ADDENDUM NO. 1

October 1, 2026

To the Contract Provisions for:
Port of Port Angeles
Pre-Engineered Metal Building

$$A = 3.0$$

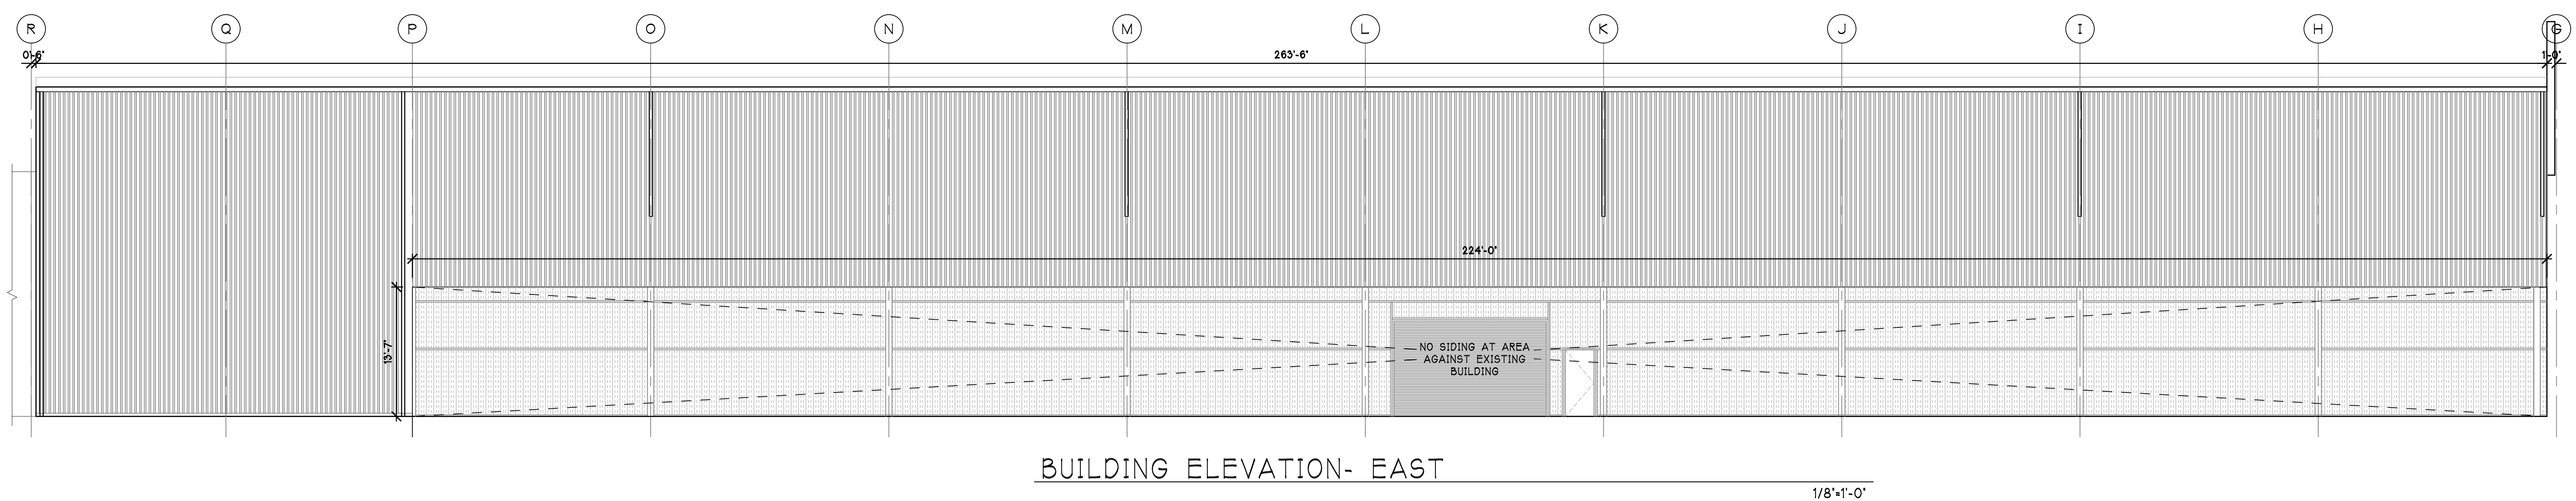
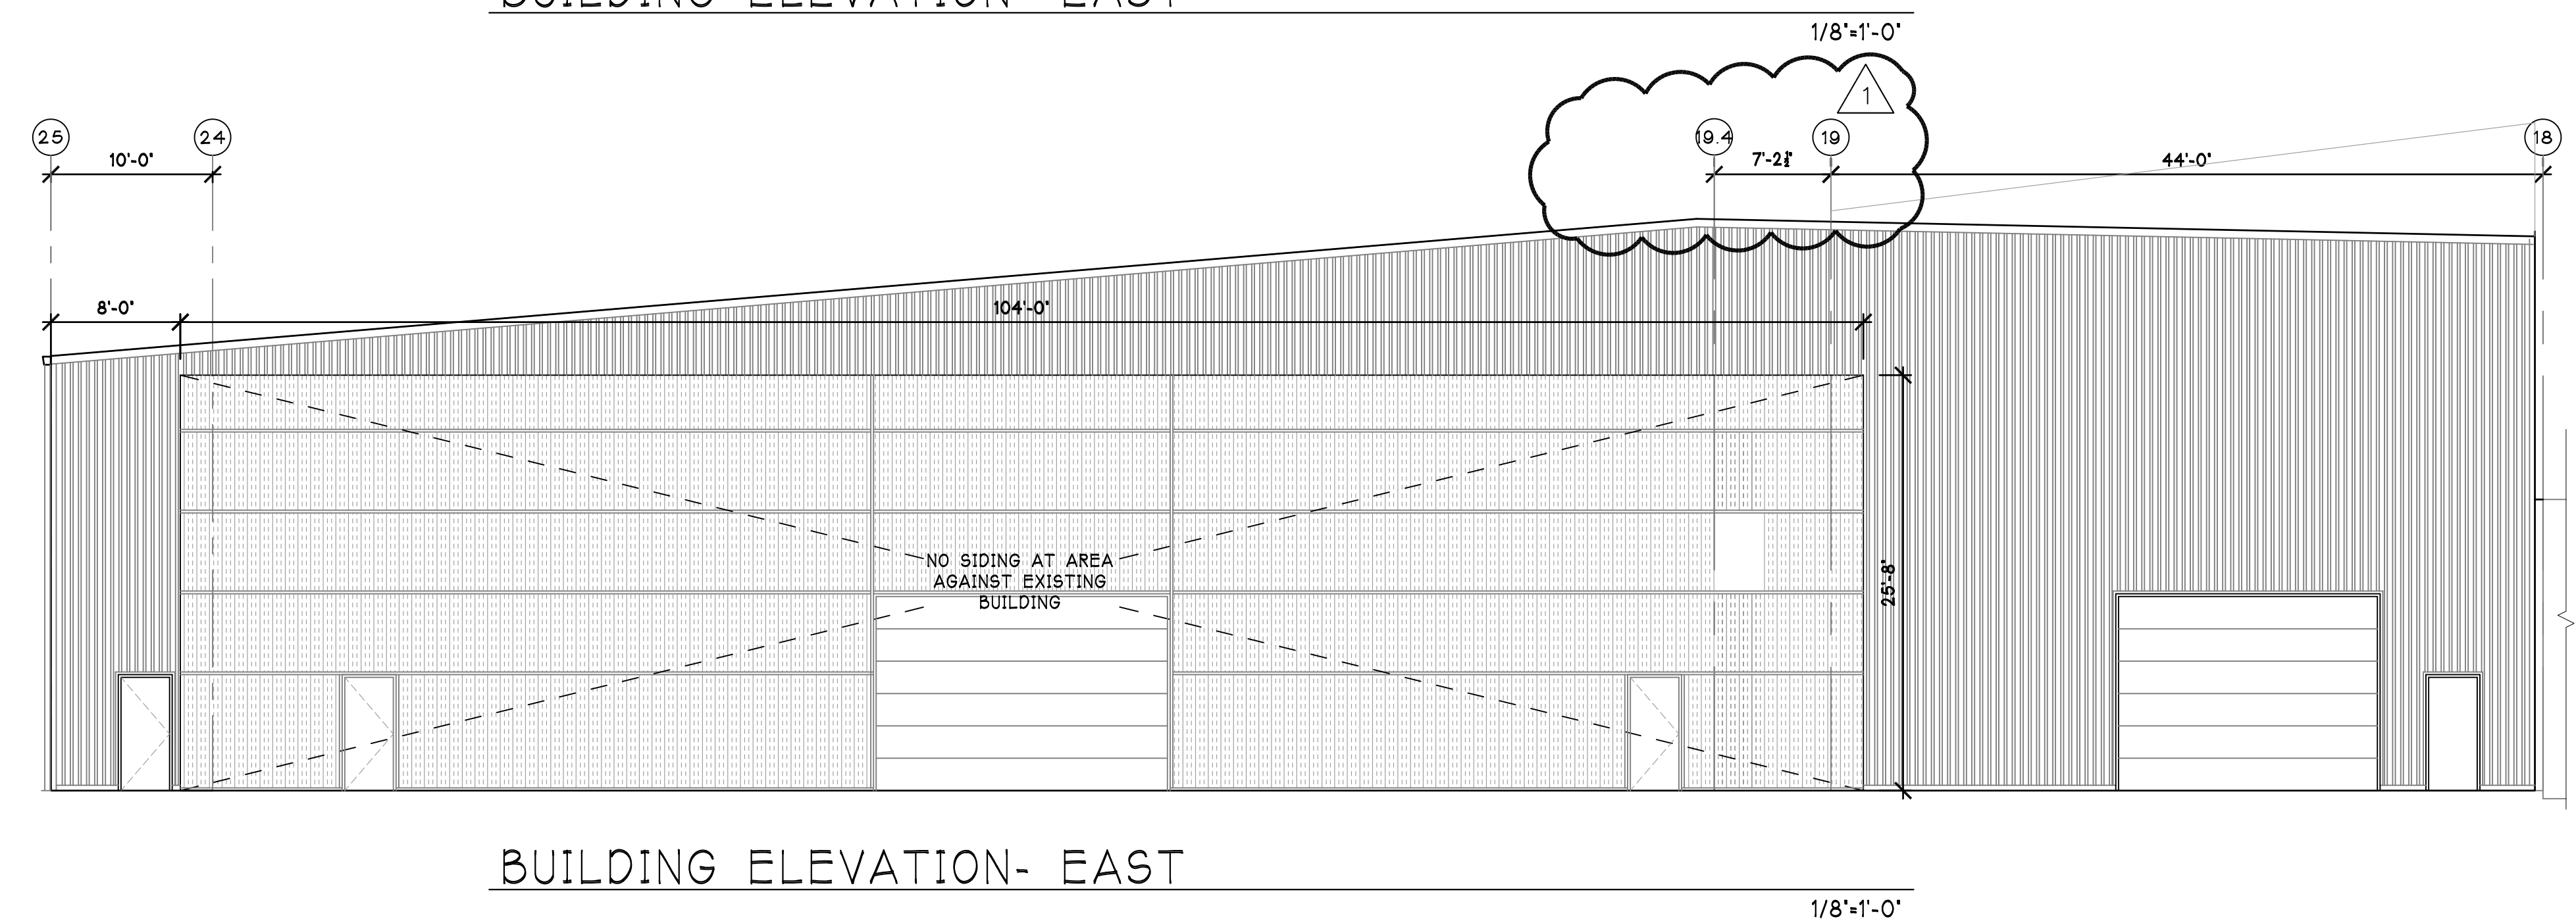
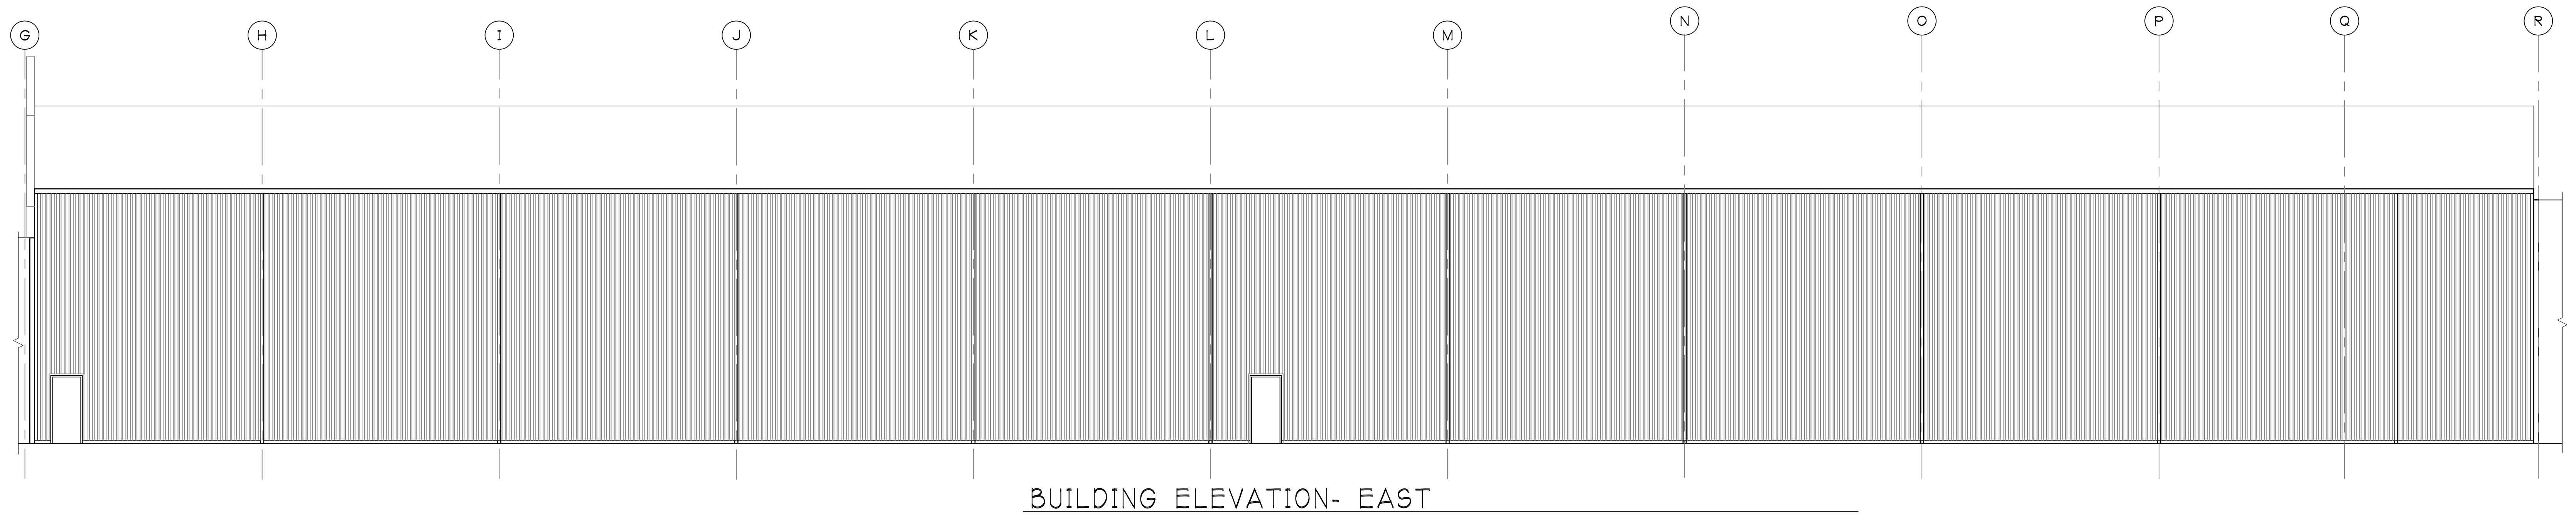
24. *Provide height to top of parapet for new PEMB on Grid Line G. Confirm parapet is only on gridline 'G' from gridline 18 to 19.*

Please note clarifying information has been added to A-3.0 Building Elevations and A-4.0 Building Sections in addition to the information provided above. All updates have been clouded and use delta #1 for this Addendum #1.

Response: Refer to revised North elevation on A-3.0 attached.

B BUILDING SECTION- NEW BUILDING

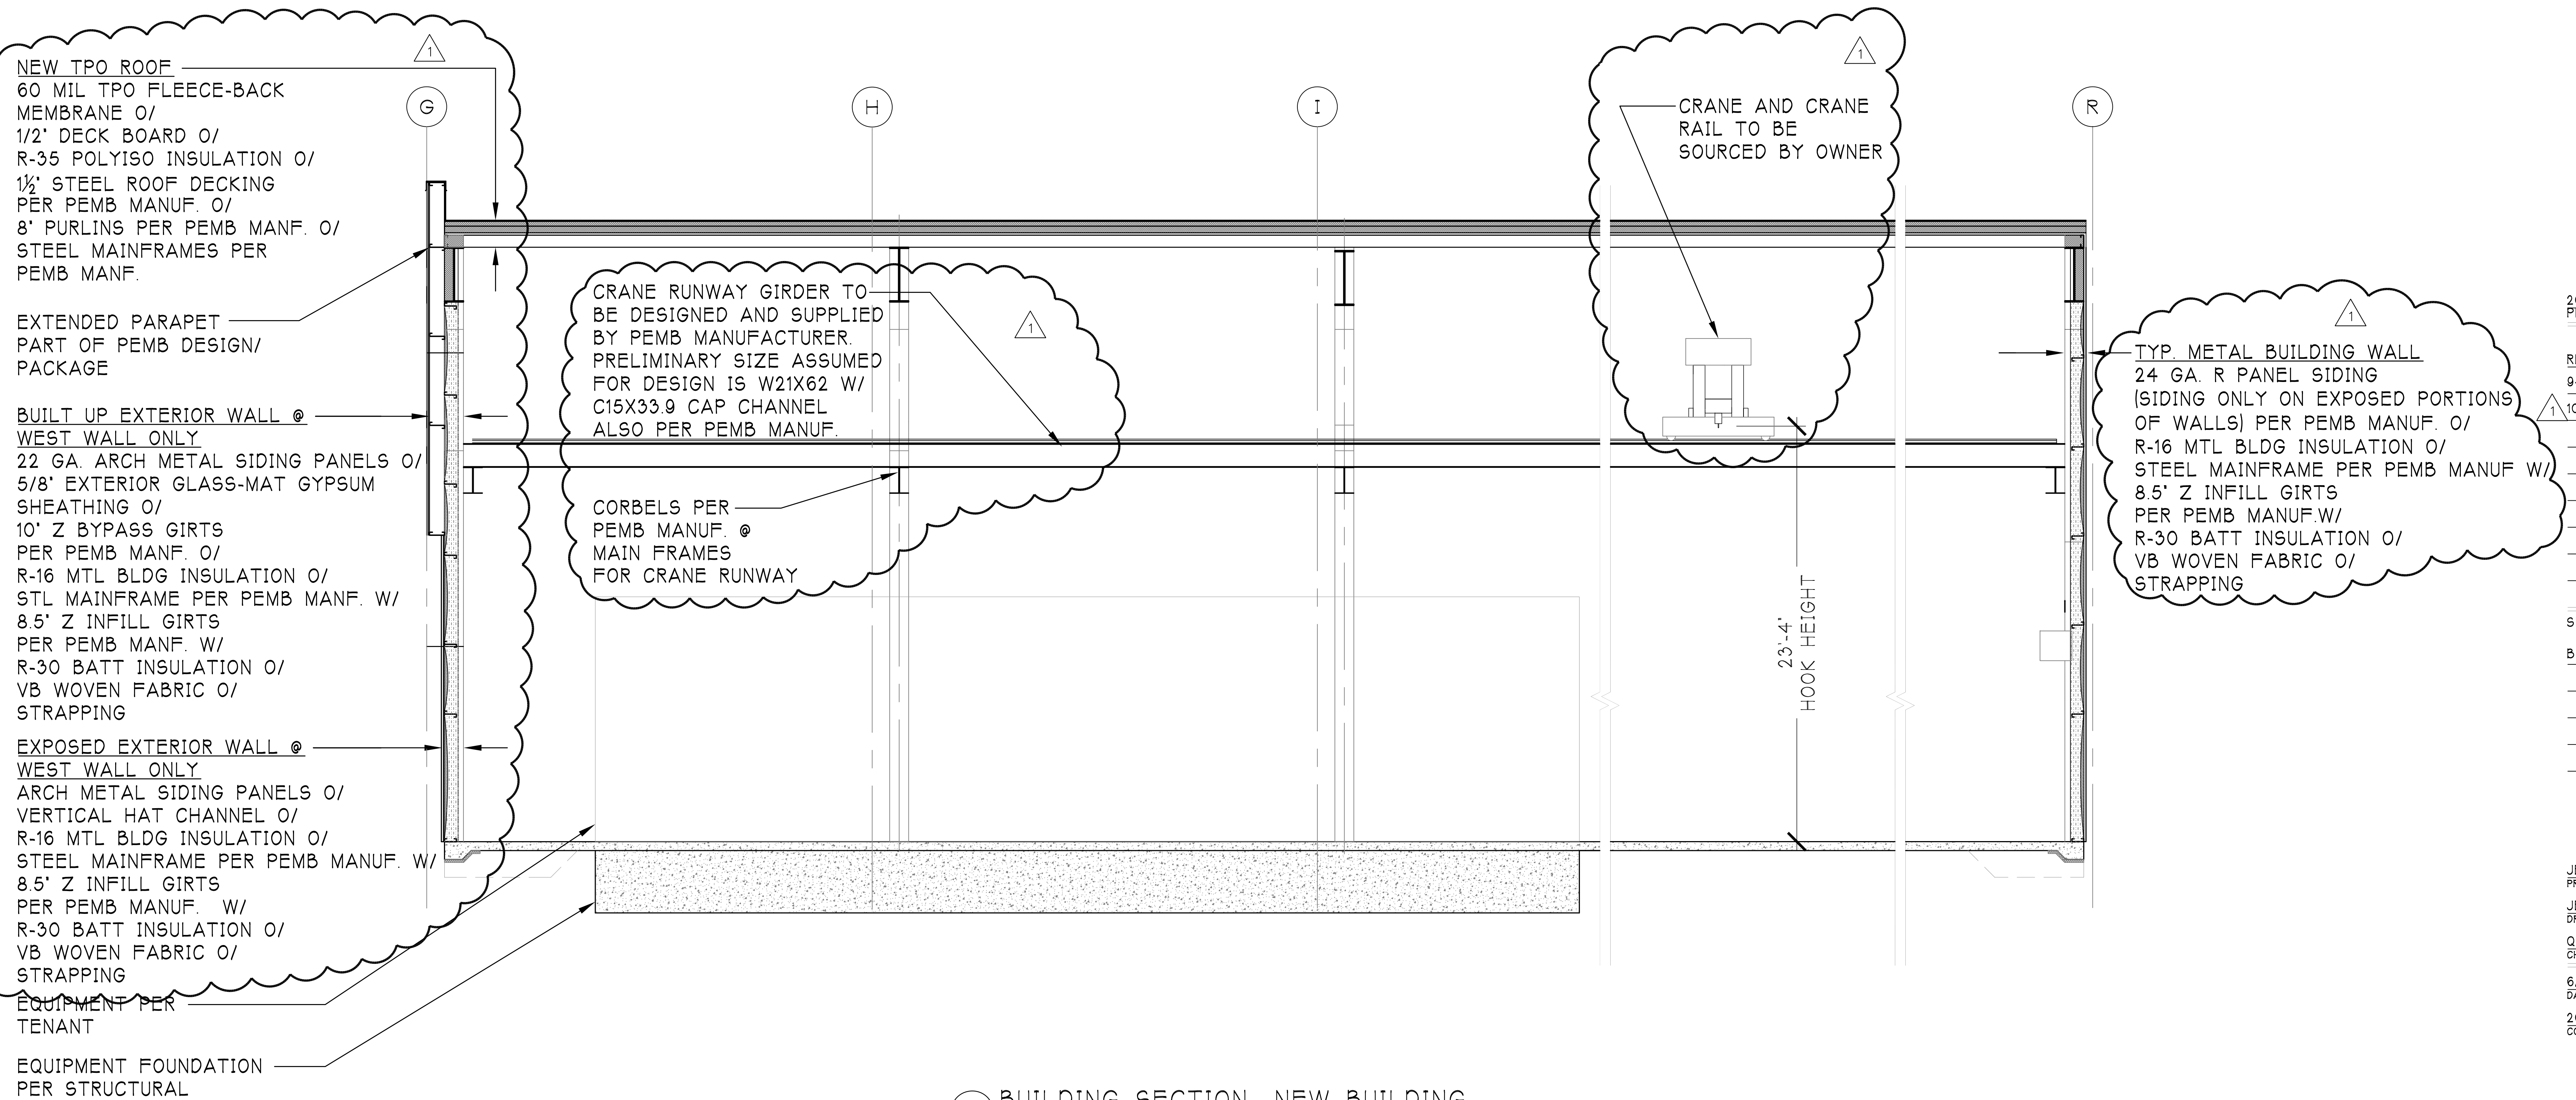
3. *TPO roof by Others? Roof crickets, parapet, and roof curbs By Others? Supply of Insulation by Others?*

Response: TPO roofing, insulation, roof crickets and roof curbs by others. North elevation, angled parapet, is per PEMB manufacturer as indicated on section B/A-4.0.
